ADDENDUM NO. 2

DATE: January 6, 2021
FROM: City of Grand Junction Purchasing Division
TO: All Offerors
RE: Persigo Wastewater Treatment Plant – Small Repairs IFB-4860-21-DH

SECTION IX STRUCTURAL
SLUDGE PROCESSING UNIT
SECOND FLOOR PLAN

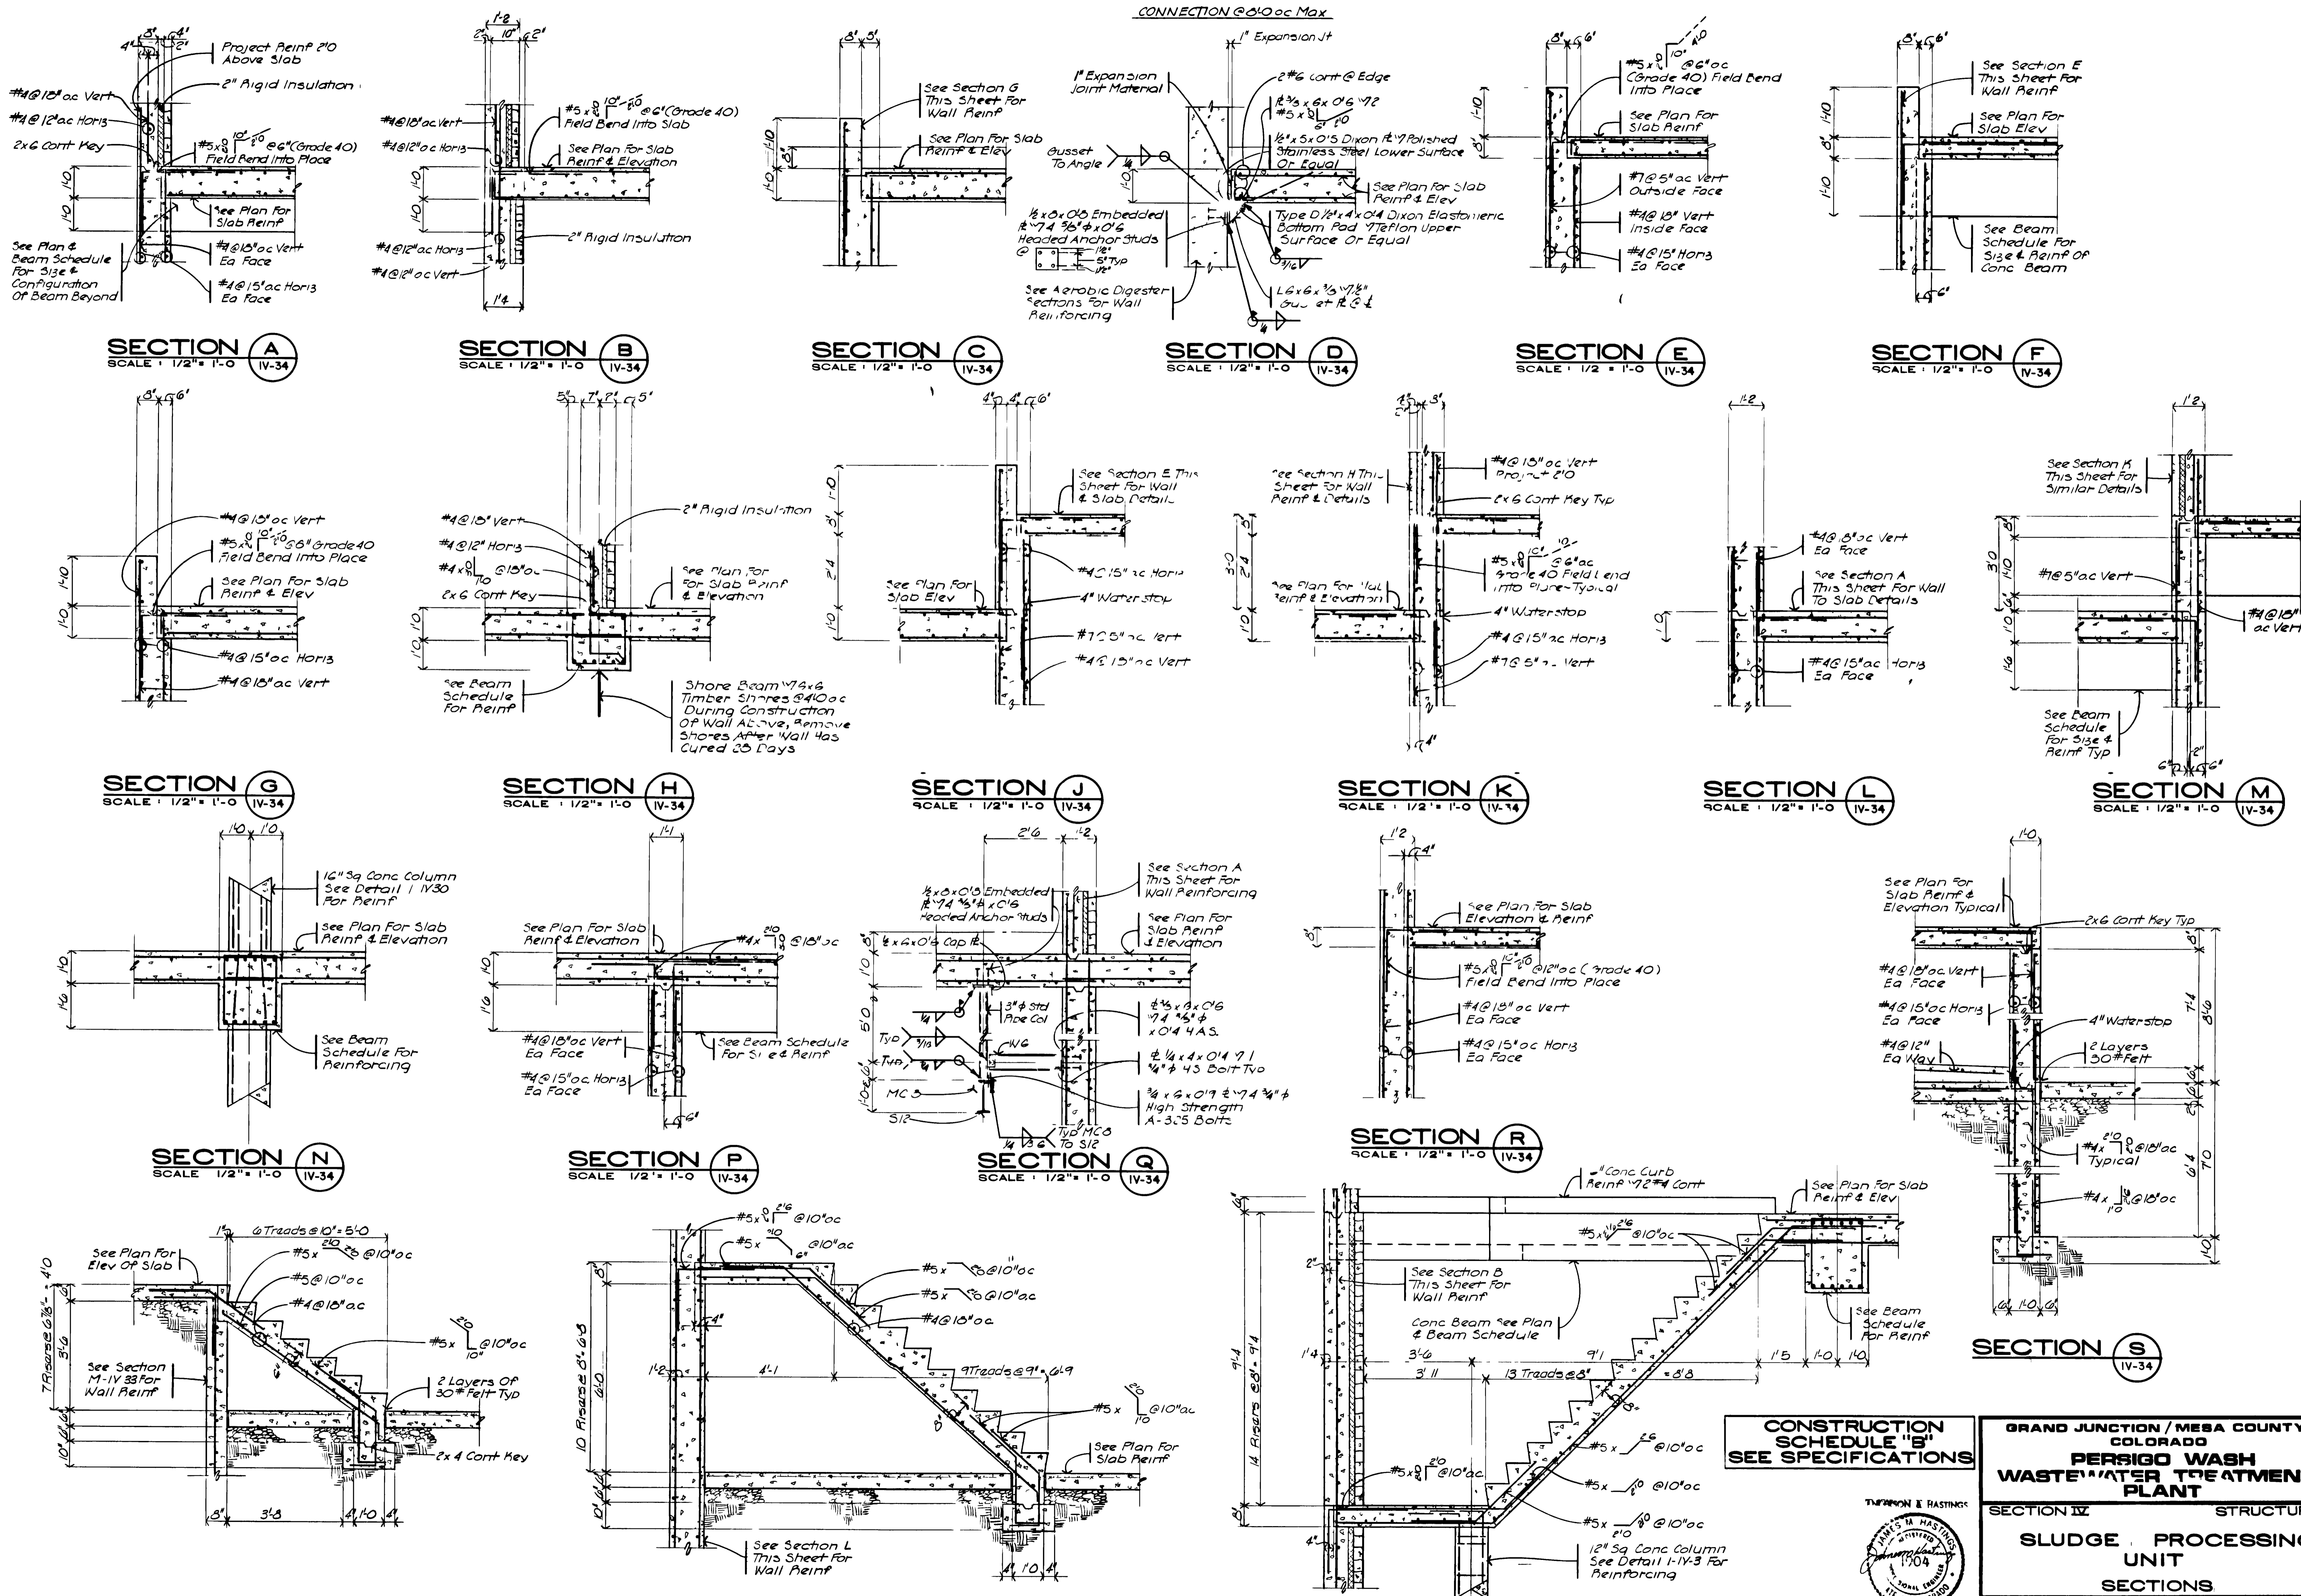
3. Q. What is the existing roof structure at the upper stairs – the Sludge Processing Building roof?

A. According to Section L of Drawing IV-11 of the existing structural drawings, this roof is a 1-foot-thick reinforced concrete slab. Included in this addendum are the existing drawings IV-31 and IV-34 for reference. Detail D / IV-34 shows the section through the roof slab.
